Project:	2022-RFT-026 821131 – Solid Waste WTS Construction		
Addendum No.	02	No. of Pages:	6
Date:	2022-07-21	Doc. No.:	P7201-1591092266-176(1.0)

The purpose of this Addendum is to clarify and answer for bidder's question on tender 2022-RFT-026 issued for bid on July 12, 2022.

SPECIFICATION 11 40 00 WTS EQUIPMENT

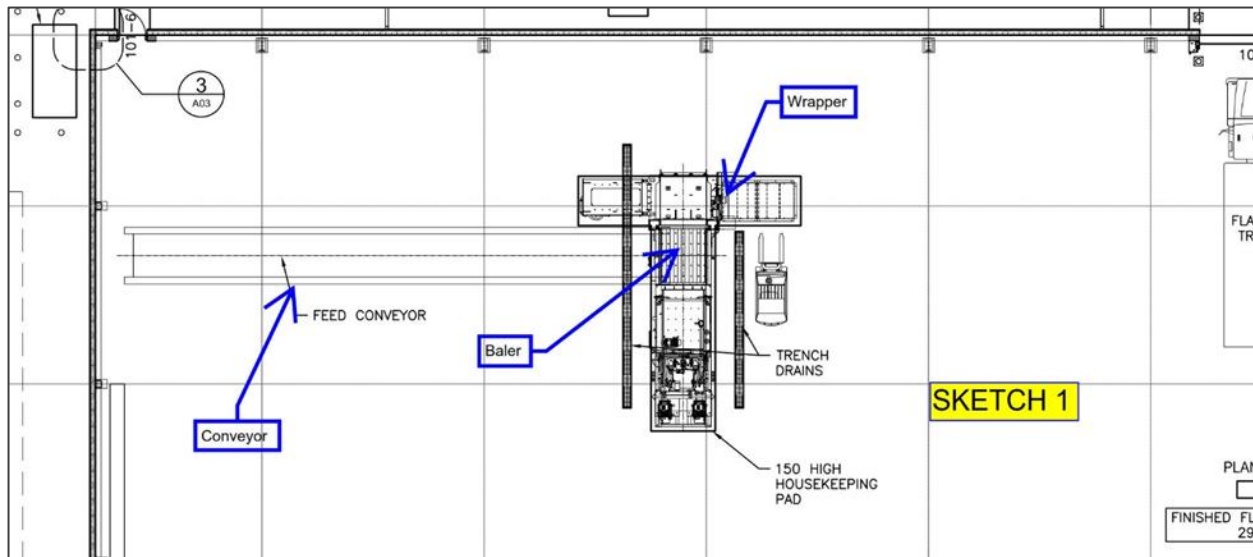
Please provide location on WTS-A01 for following items:

- 2.1 Automatic municipal solid waste baling unit
- 2.2 Steel belt conveyor
- 2.3 Bale Wrapper
- 2.5 Tire Shear and de-rimmer
- 2.6 Portable Metal Baler/Logger

Please provide a description of highlighted items on drawing WTS-A01, and confirm they are to be provided within this project.

Response 4:

The Tire Shear and De-rimmer and the Portable Metal Baler/Logger are to be delivered to the site. Please see below for the proposed location of the Conveyor, Baler and Wrapper.
